RESOURCE CONSERVATION AND RECOVERY ACT FACILITY INVESTIGATION REPORT
ADDENDUM FOR ZONE I AND U S NAVY RESPONSES TO SOUTH CAROLINA
DEPARTMENT OF HEALTH AND ENVIRONMENTAL CONTROL COMMENTS CNC
CHARLESTON SC
9/5/2001
CH2M HILL

Zone I RFI Report Addendum and Responses to SCDHEC Comments

***Charleston Naval Complex
North Charleston, South Carolina***

Re: RFI Report Addendum – Zone I

Table 10.6.4a
Detachment Confirmation Sampling for BEQs in Soil
AOC 681, Charleston Naval Complex
Charleston, South Carolina

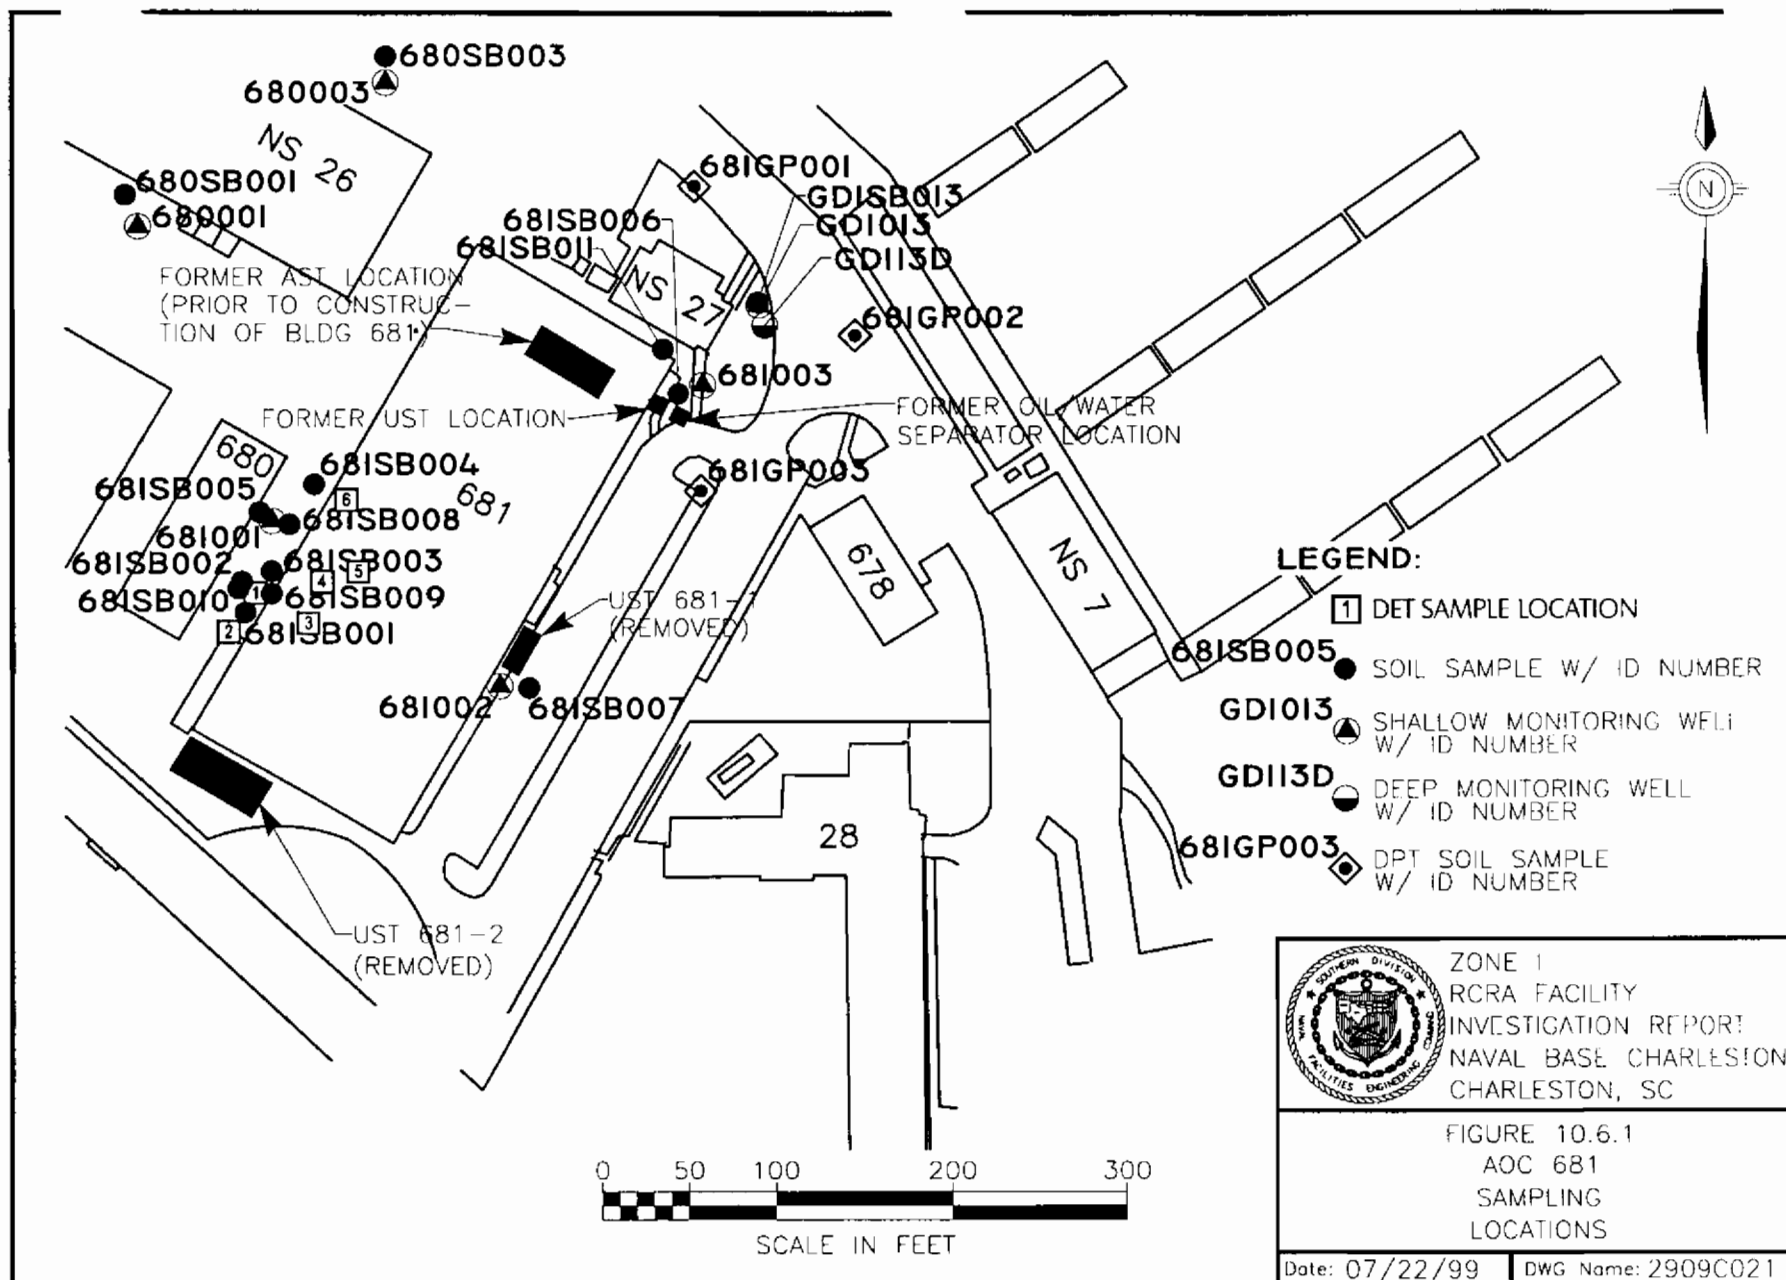
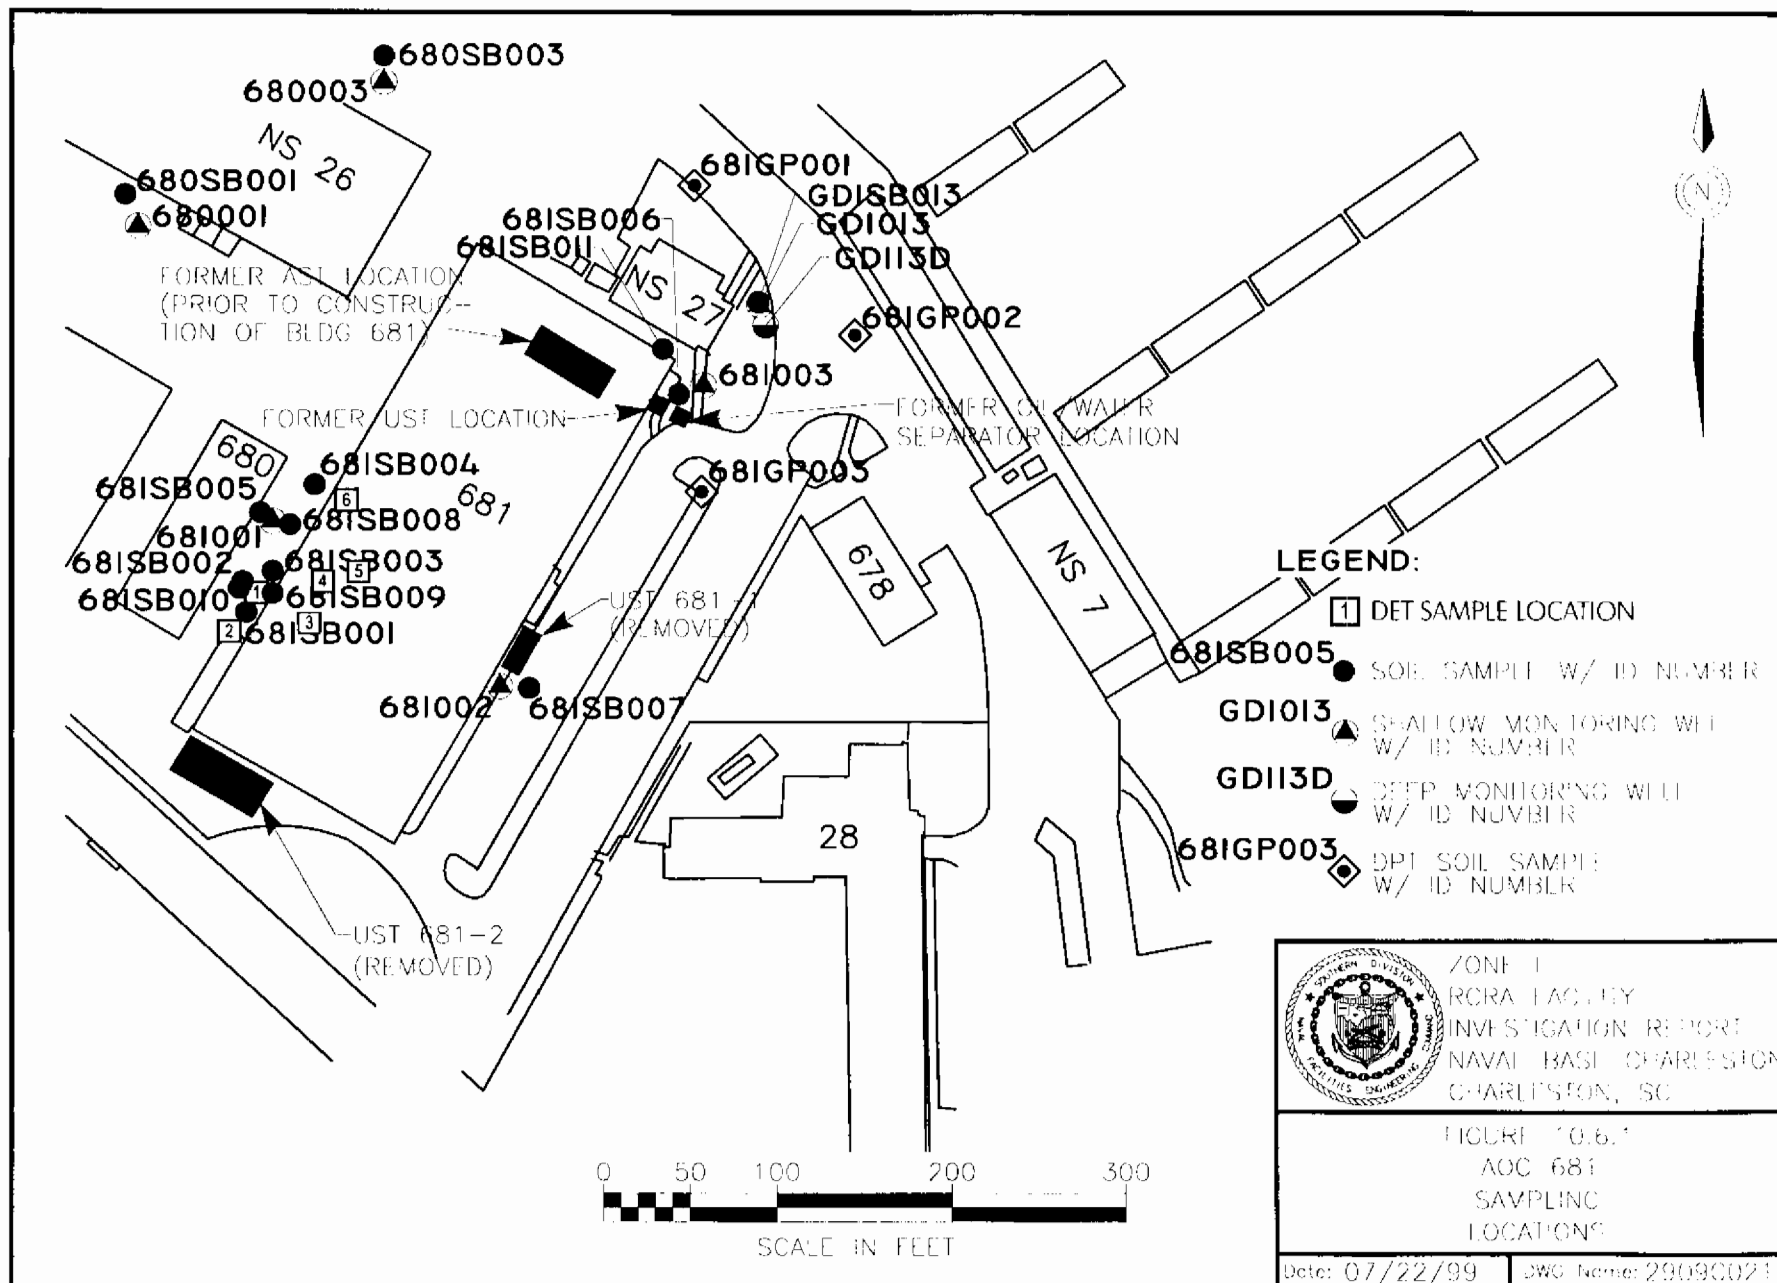
9. SVOCs (PAHs) were high at 681SB009. The total BEQs were 3445 µg/kg. For that reason "the Charleston Detachment collected 6 additional samples adjacent to and/or inside Building 681 in the vicinity of boring 681SB009. Please include all data and analysis necessary to complete the RFI for this AOC. (The Navy claims that a copy of the report (by DET) was submitted. At the time of this review, the Department did not have a copy of this report. This report was not submitted along with these addendums).

The data were originally included in the Zone I RFI Report, Revision 0 in Attachment I. However, the replacement pages (pages 10.6.29 and 10.6.29a) and a supplemental addition to Table 10.6.4 (page 10.6.27a) have been provided to include the DET BEQ values.

Figure 6.6-5
SOLID WASTE DISPOSAL AREAS

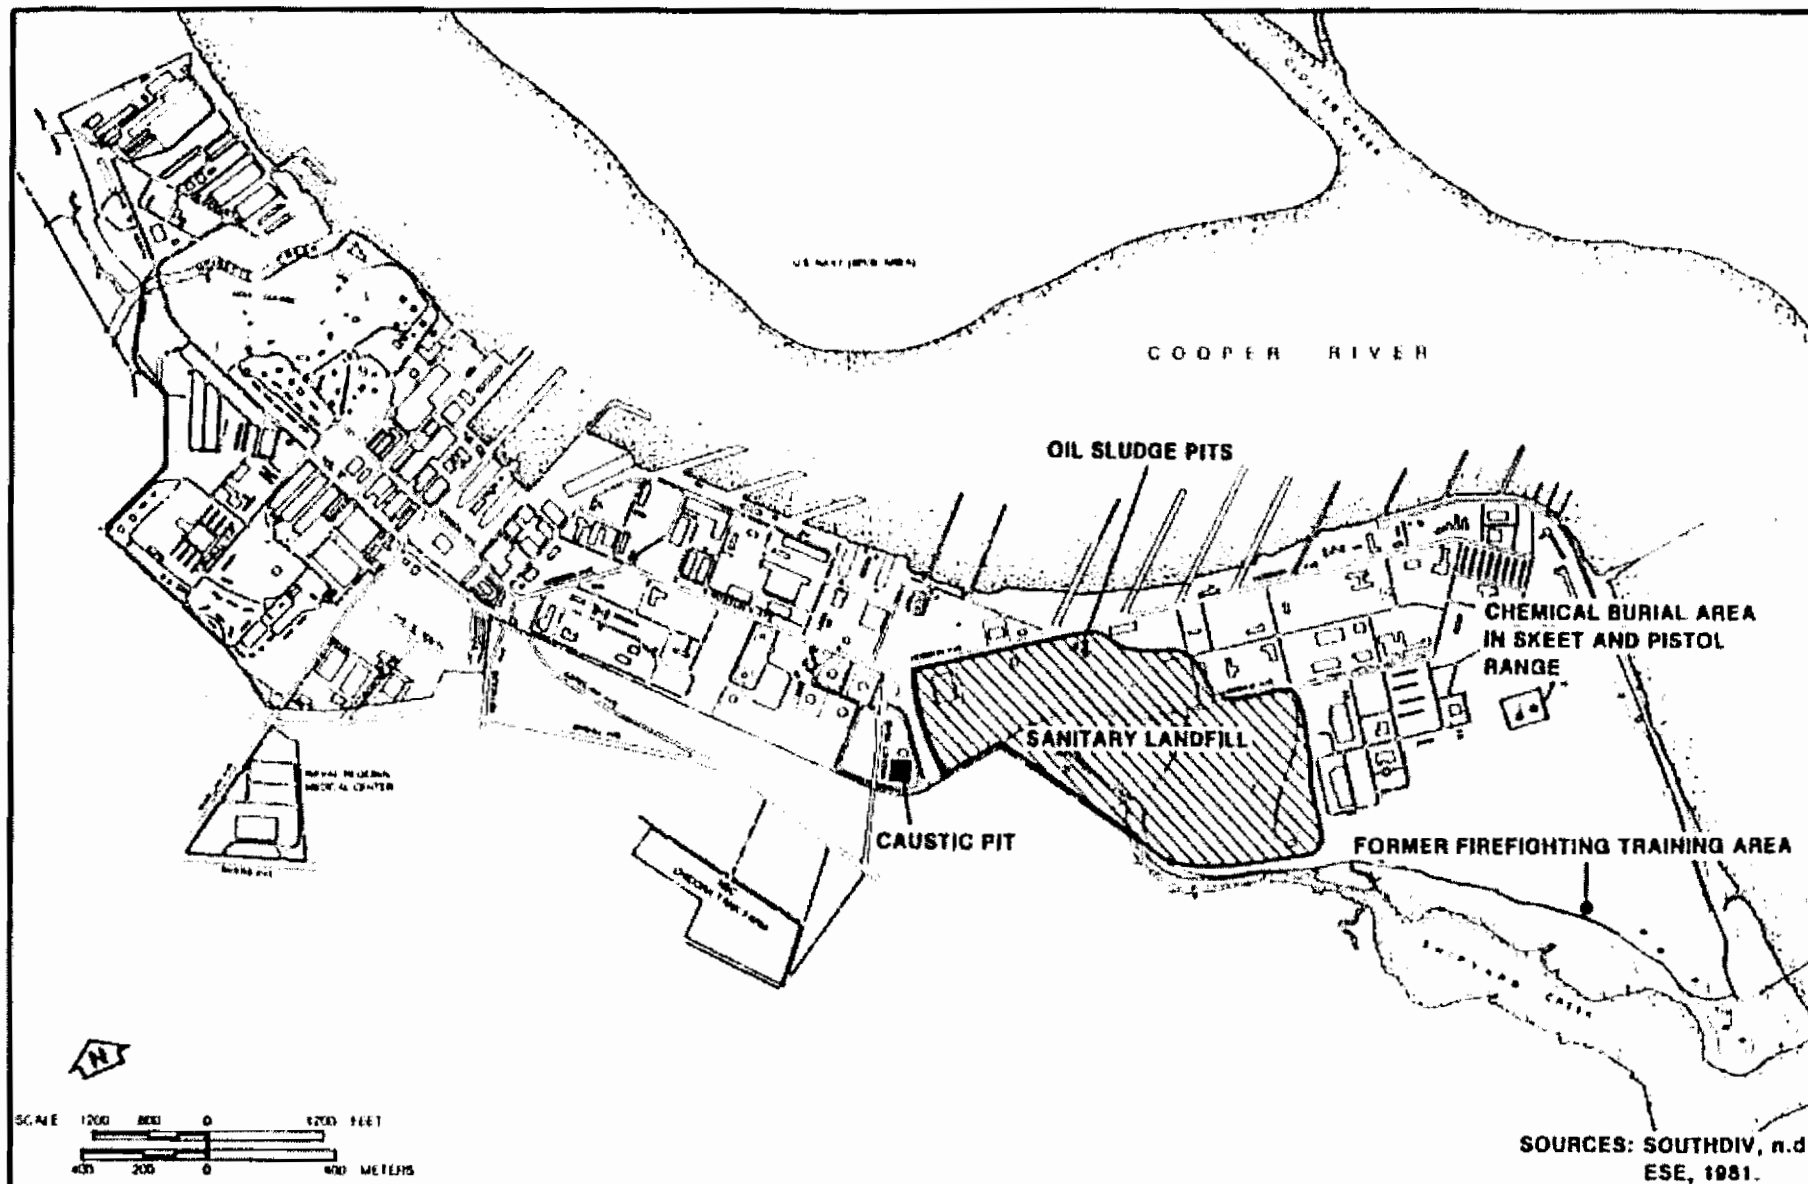
CH2M-Jones concurs with the response provided by EnSafe/Navy. However, SCDHEC has since provided an additional undated aerial photograph that shows a historical surface feature further northwest, along the same road, and has questioned whether the correct location was originally investigated for SWMU 12. Based on review of the existing database, it appears that sampling may have already been conducted in this area.

Based on research conducted in response to this comment and by obtaining the geographic coordinates relative to known features, CH2M-Jones has concluded that the feature in the vicinity of SWMU 12, cited by SCDHEC from an undated aerial photograph, does not warrant further investigation or evaluation. The area was initially investigated by a team from Environmental Science and Engineering in 1981 during the Initial Assessment Study (see Appendix A1). The field investigation did not turn up any evidence of residue from the pit. Geraghty and Miller also conducted an assessment for a confirmation study in 1982, again finding no evidence of concern in the subsurface soils or petroleum-related plumes, even though the Geraghty and Miller investigation specifically looked for potential soil and groundwater impacts (see Appendix A2).
